CMD 25-H9.2

**Written Submission from
Birch Narrows Dene Nation**

Licence Application to Prepare Site and
Construct for Denison Mines' Wheeler
River Mine and Mill Project

Submission by BNDN – February 28, 2023 – Denison Mines Corp. Wheeler
River Uranium Project Draft Environmental Impact Statement, Technical
ReviewCMD 25-H9.2 – Page 125

Figure 6: Modelled selenium migration from the ore body post-decommissioning (Ecometrix, 2022)

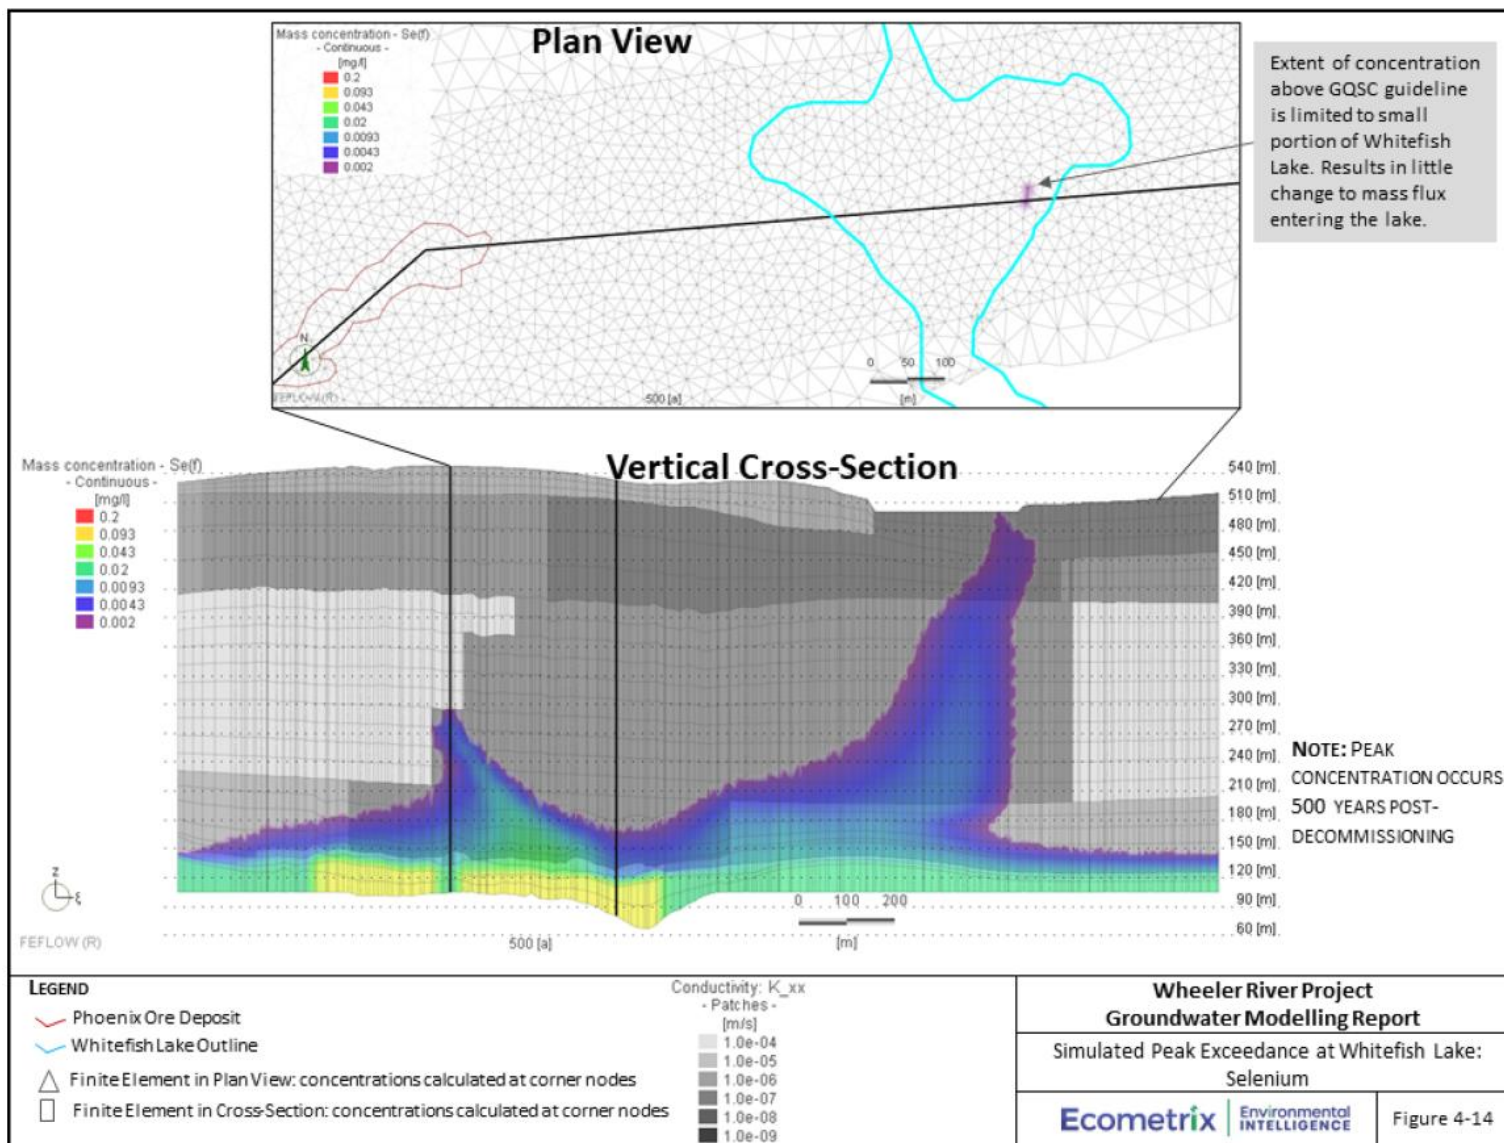
With their planned mitigation measures, Denison intends for the groundwater in the mining area to be completely isolated from the surrounding natural groundwater during mining. If their mitigation measures are as effective as they expect, there will be no impacts on the surrounding groundwater during operations when they are using ISR to extract the uranium.

After the mine is decommissioned, the freeze wall around the mining area will thaw and groundwater from the ore body (which will have high concentrations of many metals) will interact naturally with the surrounding natural groundwater. To understand how the groundwater impacted by mining will migrate and evolve over time, Denison has undertaken a detailed analysis of how groundwater will flow (using software called FEFLOW) and how the chemistry of the groundwater will change over time (using a software called PHREEQC). Denison ran several different models to predict how groundwater chemistry will flow and evolve over time. Based on their modelling, they expect mine-contaminated groundwater to flow towards Whitefish Lake. Denison's model indicates that selenium and cobalt will be the only contaminants that reach Whitefish Lake in concentrations above water quality guidelines. They expect the peak contamination of selenium to occur 500 years post-decommissioning of the mine, and peak cobalt contamination to occur 30,000 years post-decommissioning of the mine. Based on their model, they expect the changes to Whitefish Lake from the groundwater migration to be essentially undetectable in Whitefish Lake.

Figure 8. Study Area Boundaries for Fish and Fish Habitat of the Wheeler River Project (Denison, 2022)

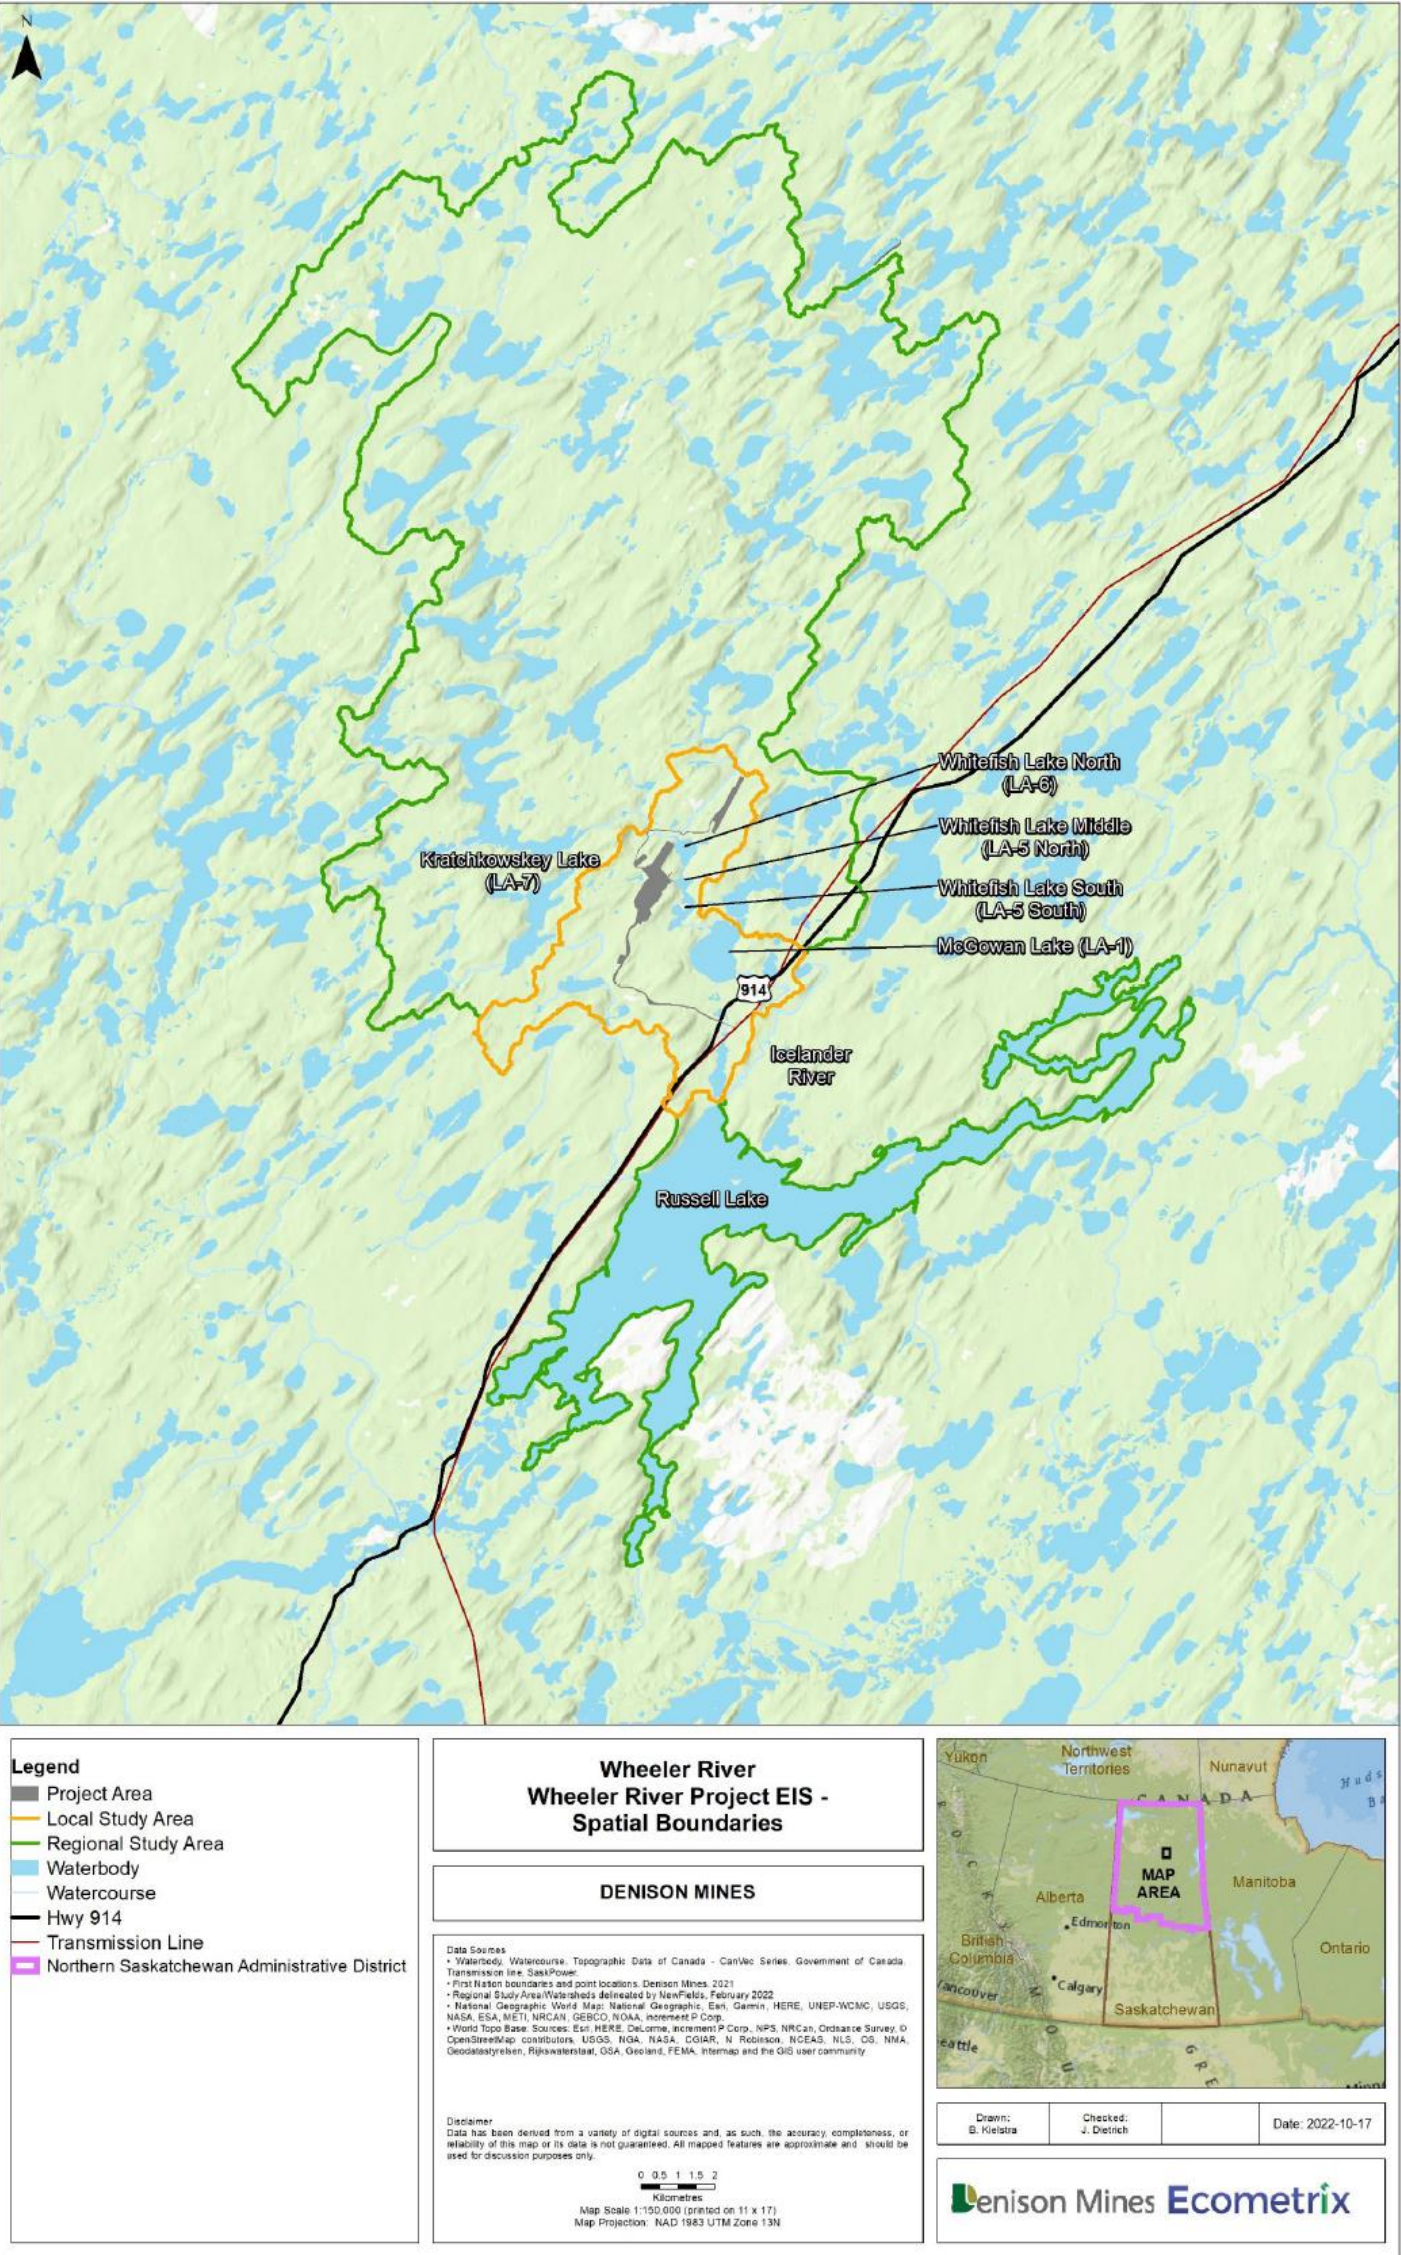
The proposed Wheeler River Mine occurs in the Iceland River watershed that drains into Russell Lake (Figure 8). Baseline water quality of lakes and streams within the RSA are generally below applicable guidelines for protection of aquatic life. However, concentrations of aluminum, lead, iron, and cadmium all showed some exceedances over guidelines. Sampling of benthic invertebrates in baseline studies of McGowan Lake, and Whitefish Lake found communities that are typical of depositional environments with species of chironomids, midges, water fleas, and worms. Sediments in these lakes are also typical of depositional environments, with primarily small particles such as clay dominating and lesser amounts of silt and sand in areas of higher water velocity. Background concentrations of metals and other contaminants in sediment are at or below applicable guidelines in most instances. Fish identified in the study area inhabit rivers, streams and lakes within the RSA. This includes lake trout, lake whitefish, northern pike, walleye, burbot, yellow perch, arctic grayling, and several suckers and small-bodied species (e.g. lake chub, spottail shiner, and ninespine stickleback).
